COMMUNITY  
BROADCASTING  
ASSOCIATION OF  
AUSTRALIA

# Proposal to vary the Queensland digital radio channel plan

Comments on the ACMA Consultation Paper, July 2021

CBAA comments on the July 2021 ACMA consultation paper

# Area and population within Brisbane RA1 negatively affected by Alternative 1 coverage compared to ACMA September 2020 coverage

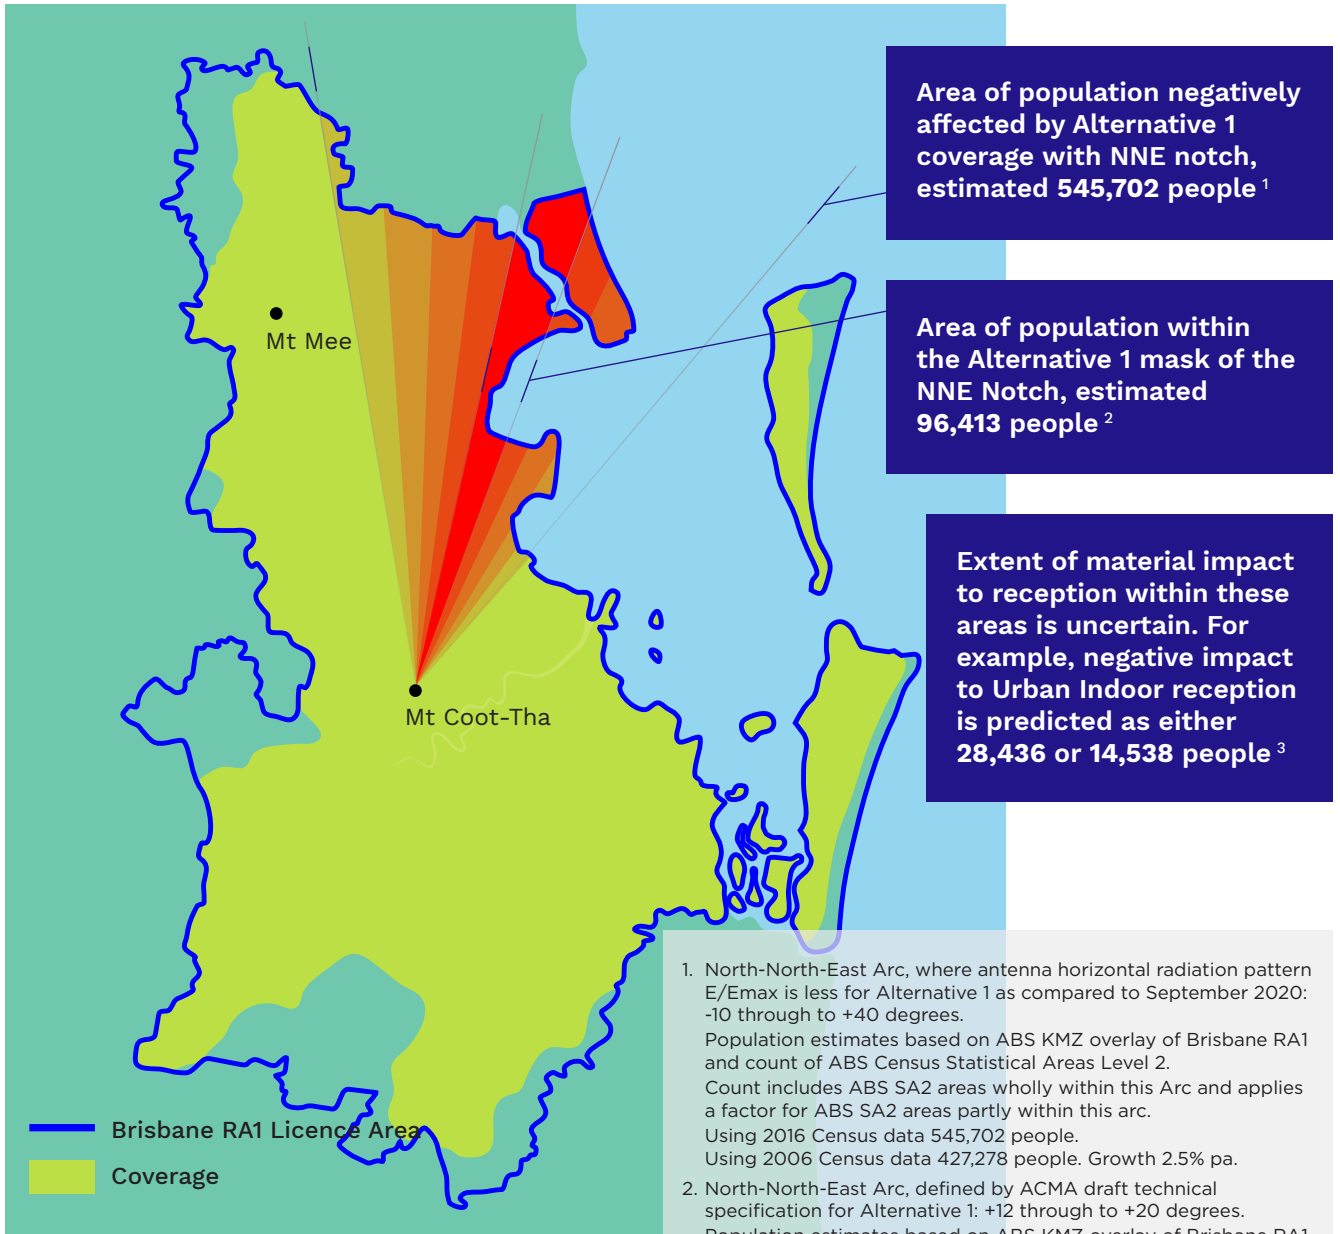
- 3.21 What can be said with certainty is that the deliberate insertion of a notch to reduce field strength will reduce the efficacy of reception to the population of Brisbane RA1 Licence Area in those areas where the field strength is less than it would have been under the September 2020 proposal.

- 3.22 Those areas are described by reference to the practical antenna horizontal radiation patterns, shown in the ACMA July 2021 Paper at Appendix G.
- 3.23 When compared, these antenna patterns show the North-North-East arc where the E/Emax is less for Alternative 1 as compared to the September 2020 proposal is approximately -10 through to +40 degrees.

- 3.24 Attachment 1 shows that arc overlaid upon the Brisbane RA1 Licence Area.
- 3.25 A population count within this arc has been performed. The population within this arc is estimated as being 545,702 people, using 2016 Census data.<sup>3</sup>

- 3.28 Another measure is to assess the population count within the arc defined by the mask set out in the draft technical specification for Alternative 1. This narrower arc is from +12 through to +20 degrees.
- 3.29 A population count within this arc is estimated as being 96,413 people using 2016 Census data. The growth trend seems even more significant within this narrower arc: the population count using 2006 Census data is 67,355 people, 3.7% pa compounding.
- 3.30 The two 2016 population counts of 545,702 people and 96,413 people might be considered as ways of describing the total population in the area of reduced coverage under Alternative 1, and has a high degree of certainty.

## Antenna horizontal radiation pattern options

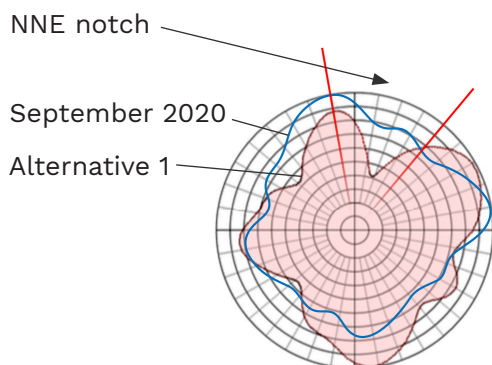
1. North-North-East Arc, where antenna horizontal radiation pattern E/E<sub>max</sub> is less for Alternative 1 as compared to September 2020: -10 through to +40 degrees. Population estimates based on ABS KMZ overlay of Brisbane RA1 and count of ABS Census Statistical Areas Level 2. Count includes ABS SA2 areas wholly within this arc and applies a factor for ABS SA2 areas partly within this arc. Using 2016 Census data 545,702 people. Using 2006 Census data 427,278 people. Growth 2.5% pa.

2. North-North-East Arc, defined by ACMA draft technical specification for Alternative 1: +12 through to +20 degrees. Population estimates based on ABS KMZ overlay of Brisbane RA1 and count of ABS Census Statistical Areas Level 2. Count includes ABS SA2 areas wholly within this Arc and applies a factor for ABS SA2 areas partly within this arc. Using 2016 Census data 96,413 people. Using 2006 Census data 67,355 people. Growth 3.7% pa.
